主旨: Fw: S. 16 Planning Application No. A/YL-KTN/1250 - Departmental Comments
附件: (4)LD-L1198ARP-APP01(用途分佈圖).pdf; (4)S.16-III_商店_KTN1250.pdf; (4)行車路線圖_KTN1250.pdf; (4)回應意見(30June2026).pdf

S. 16 Planning Application No. A/YL-KTN/1250 - Departmental Comments

Temporary Shop (Metal Scaffolding) and Ancillary Office
at Lot 1198ARP (Part) in DD109, Kam Tin North, Yuen Long, N.T.

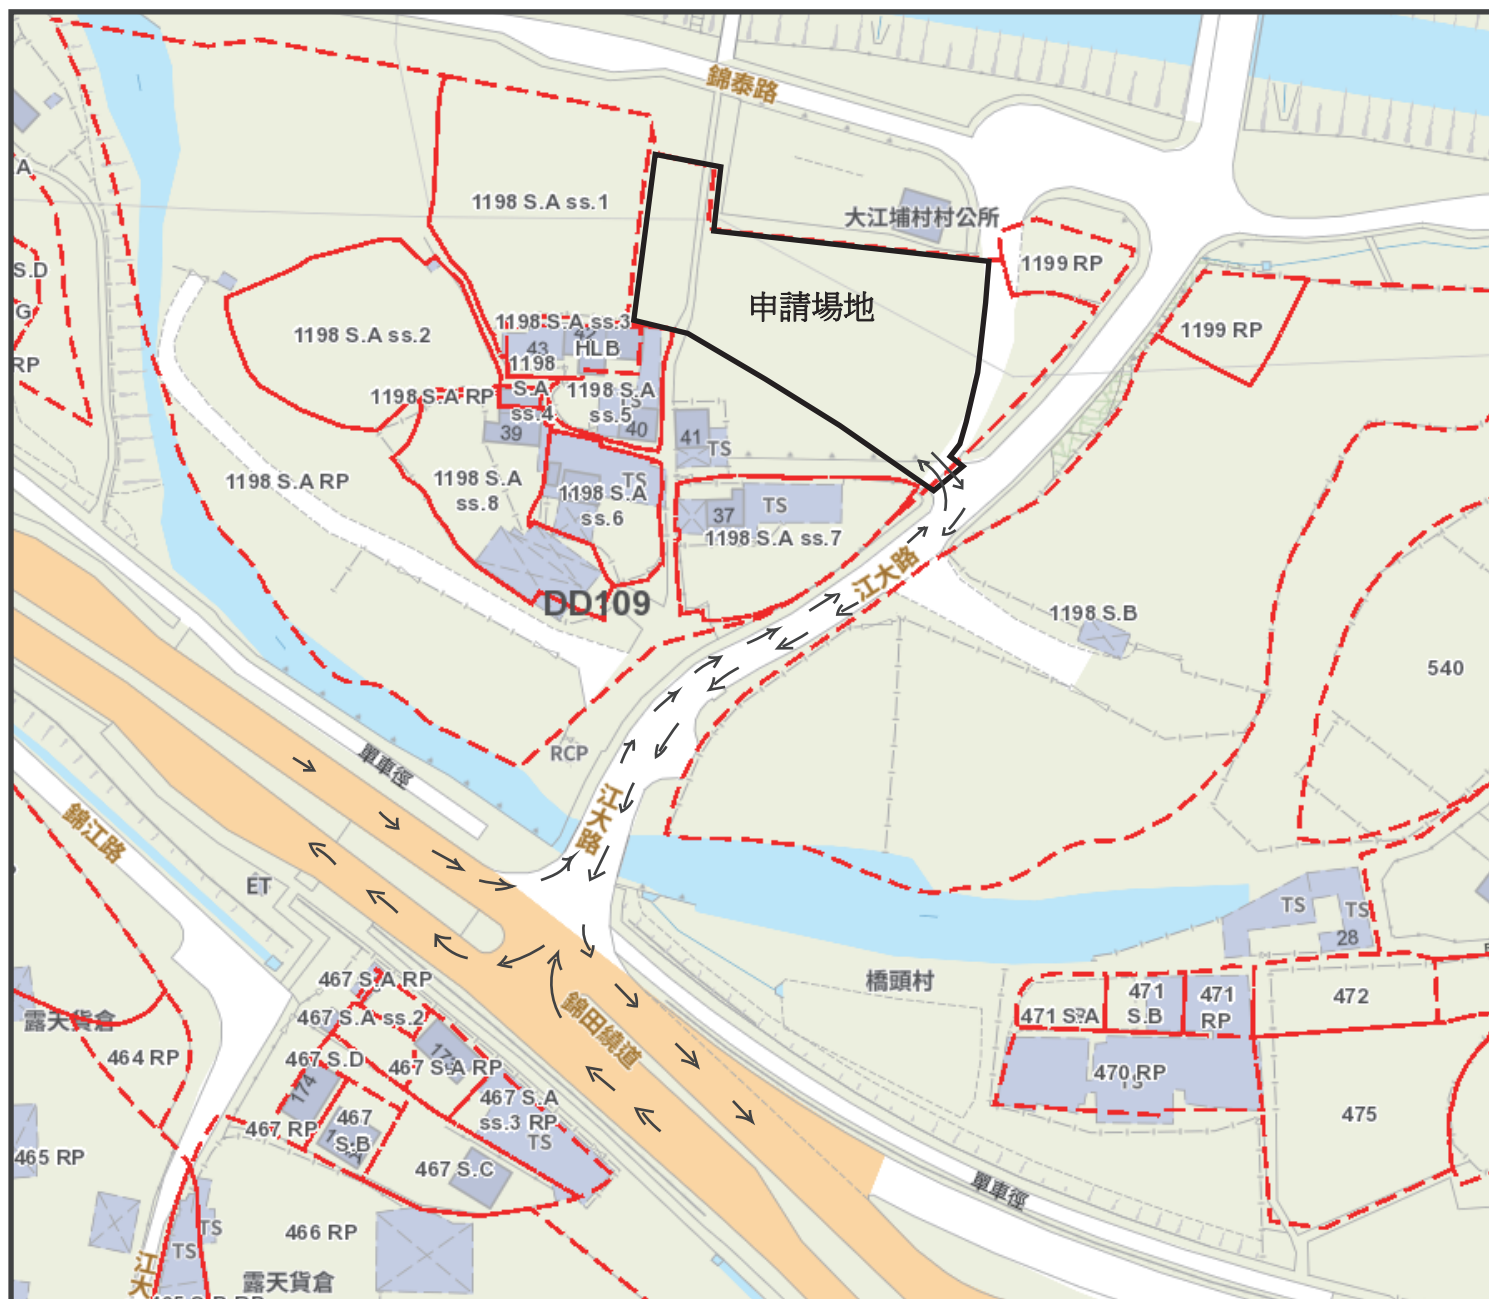
- as indicated in page 8 of the Application Form, display of the erected metal scaffold will be provided within the Site. Please provide some photos for illustration purpose;

as indicated in page 3 of the Application Form, the Site is currently being used as open storage. Please elaborate the items currently stored at the Site;	是次申請場地現在是存放金屬架，場地範圍目前尚未全部用作商店和服務場所，預計會在申請場地北面暫時放置一個二十呎貨櫃，準備在申請批出後，在室外收納區內存放金屬棚架及配件，其中包括直杆、橫杆、斜杆、拱橋、踏板、揭蓋板、踢腳板、底座、短腳套、頂積、駁蕊手扣及雙尖扣等搭建臨時用作示範各款式金屬棚架，對工程客戶、顧問工程公司及第三方化驗室批核使用証書的實地測度要求。
as indicated in page 8 of the Application Form, display of the erected metal scaffold will be provided within the Site. Please provide some photos for illustration purpose;	搭建好的金屬棚架將在現場展示，搭建物的最高高度約 4 米。參考照片如下；
